Regarding: 1221 Williamson Street – Third Lake Ridge Historic District - Exterior alterations involving the construction of additions and exterior alterations adjacent to a designated landmark (Sixth Ward public Library). 6th Ald. District.
Contact: Matt Aro, Aro Eberle Architects (Legistar #28487)

Date: December 10, 2012
Prepared By: Amy Scanlon, Preservation Planner

1221 Williamson Street
 Visually Related Study Area
 Landmarks Commission - 12/10/2012

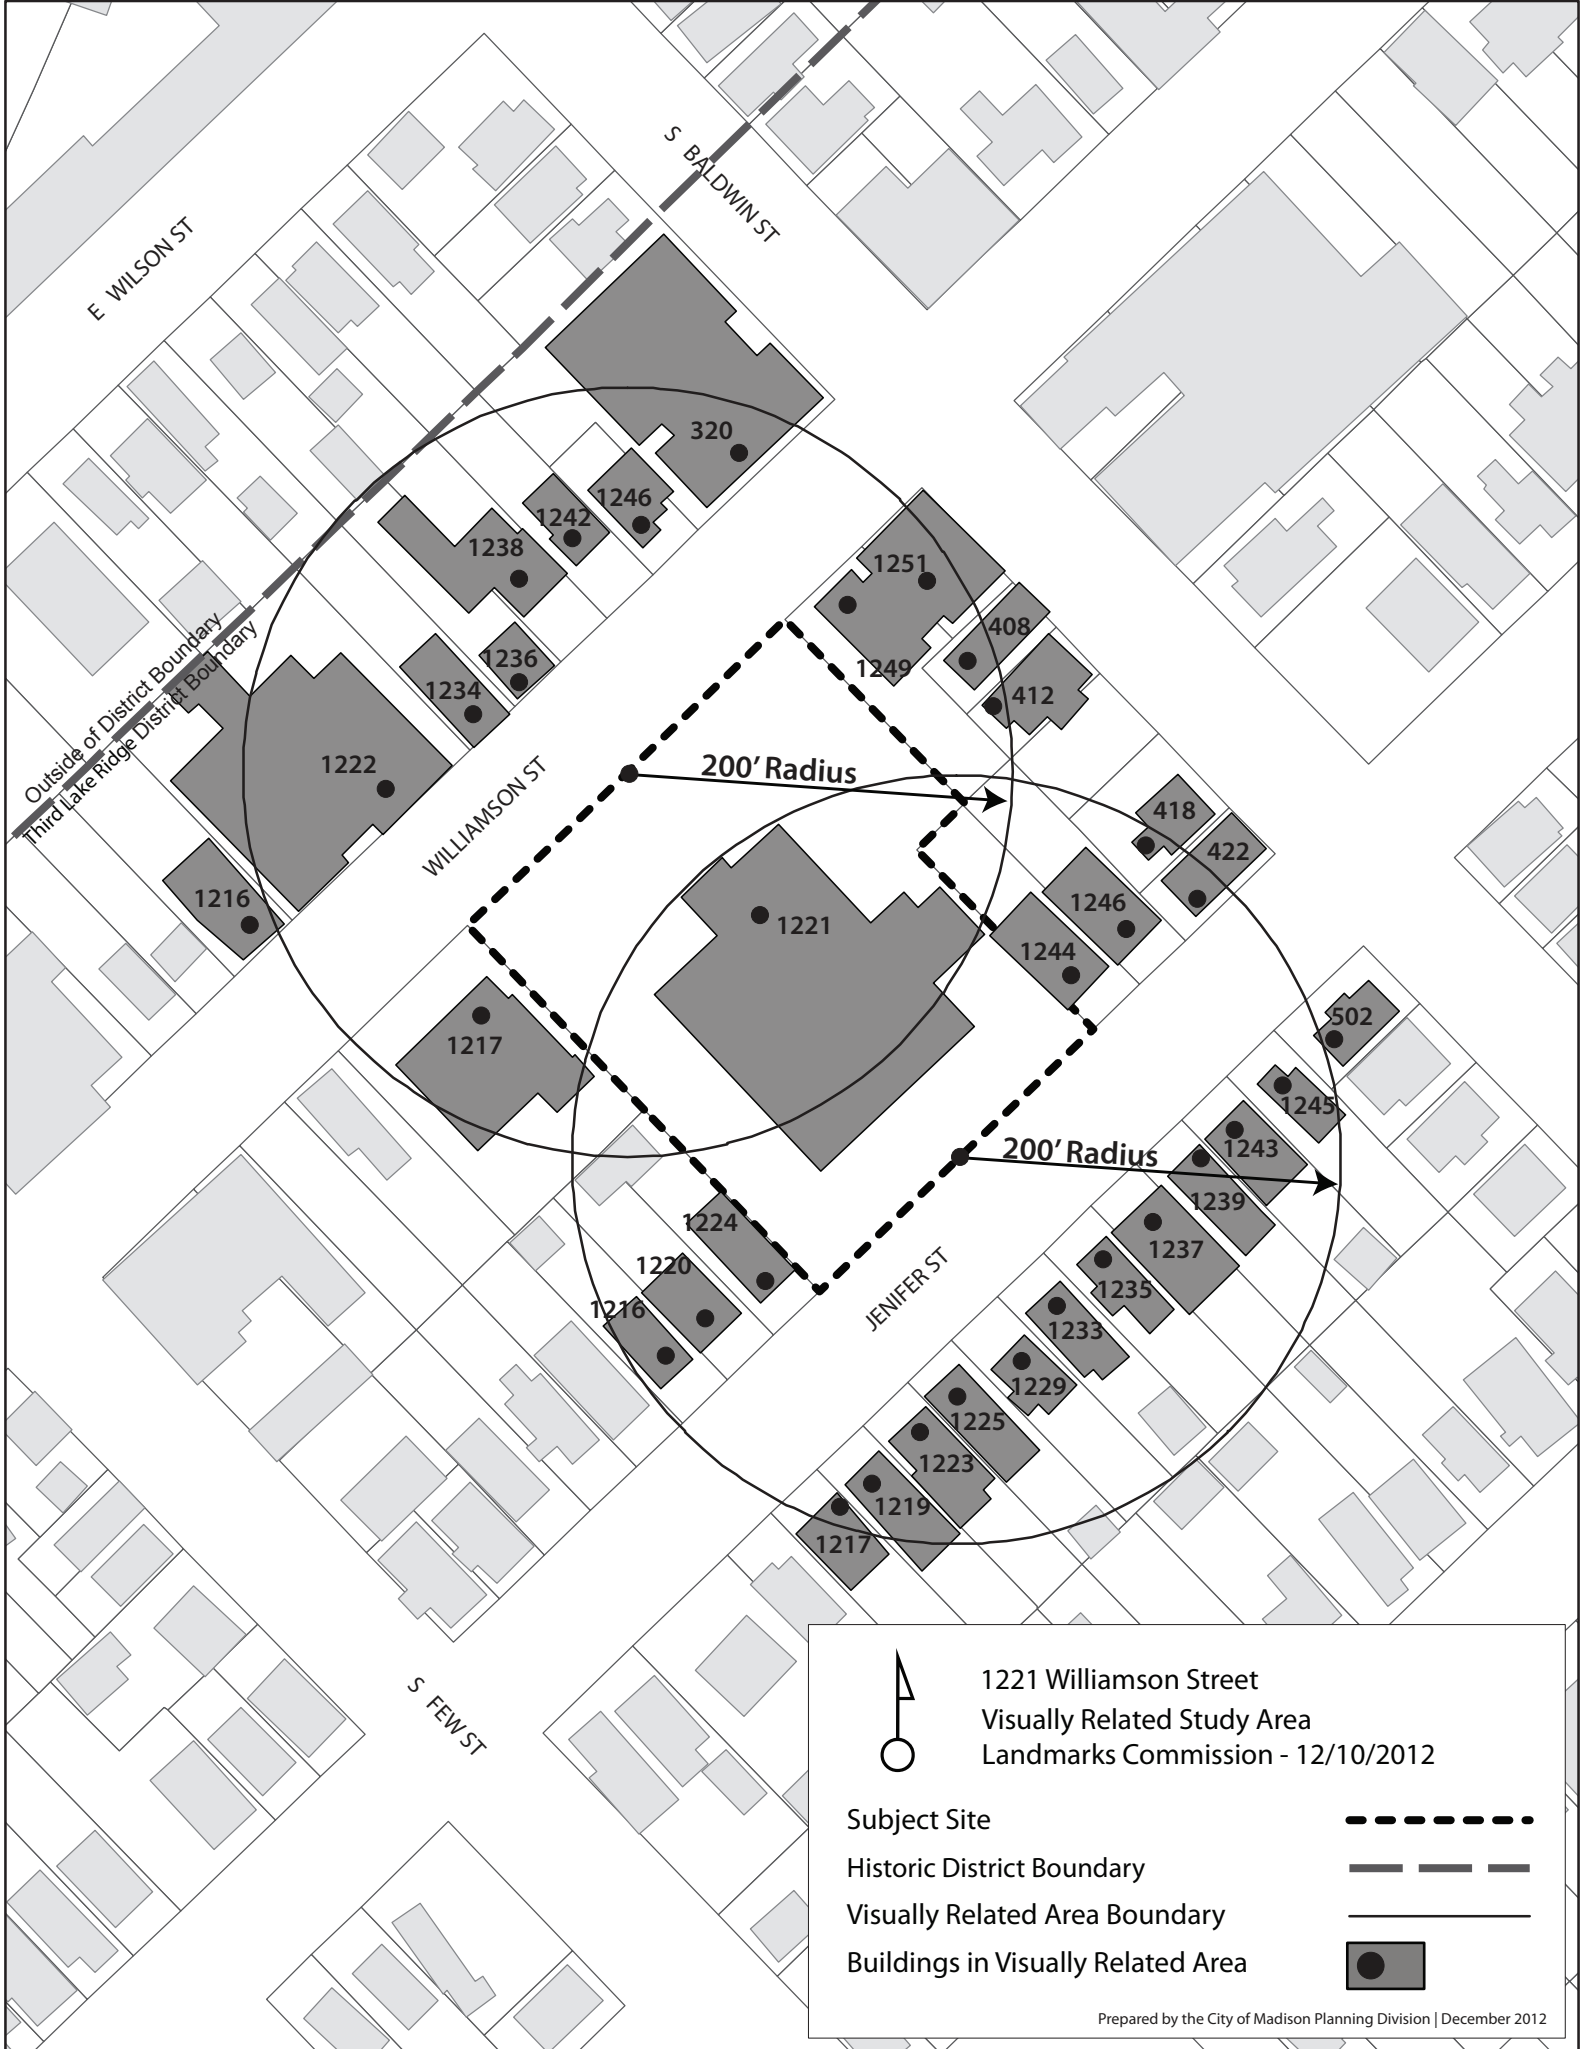
1. The buildings in the visually related area are primarily two story (see attached map). Some buildings are two story with flat roofs while other buildings are two story with pitched roofs.
2. The original rhythm of solid and voids is being retained where applicable. One portion of the addition is on the street façade which will be placed in front of the existing openings. The size of the existing openings is being replicated in the new wall at the first floor and that rhythm is being repeated at the new second story.
3. The brick of the new addition will match the existing adjacent brick color, size, texture and coursing pattern as noted in the submission drawings.
4. The building will maintain a flat roof form.
